BOLLETTINO TECNICO / TECHNICAL BULLETIN**Confronto tra / Comparison between
24-1071/ PA1071/ 101071 (24-1358/ PA1358/ 101358 with backhousing) and
24-1072/ PA1072/ 101072 (24-1359/ PA1359/ 101359 with backhousing)**

**24-1071
(24-1358 with backhousing)****24-1072
(24-1359 with backhousing)**

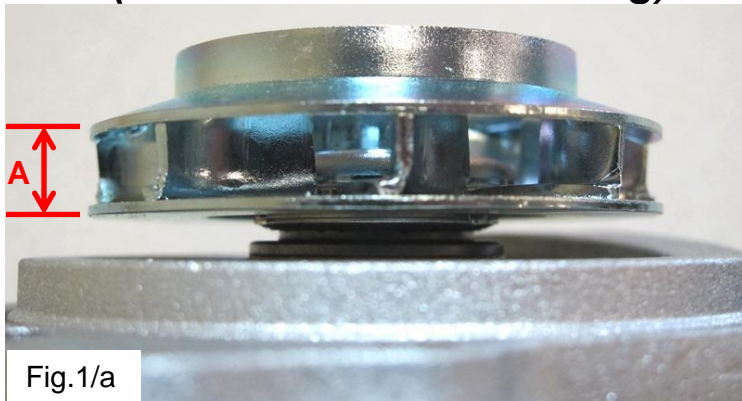
Nelle immagini 1/a e 1/b si evidenzia la maggiore altezza delle alette della girante della PA 24-1072 (quota A). Nell'immagine 2 viene evidenziata la differenza del numero delle alette; N°8 per la girante della PA 24-1071 e N°6 per la girante della PA 24-1072.

In the pictures 1/a and 1/b it can be noted the greater height of the WP 24-1072 impeller wings (measurement A). In the picture N°2 it should be noted the wings number difference; N°8 for the impeller of the WP 24-1071 and N°6 for the impeller of the WP 24-1072.
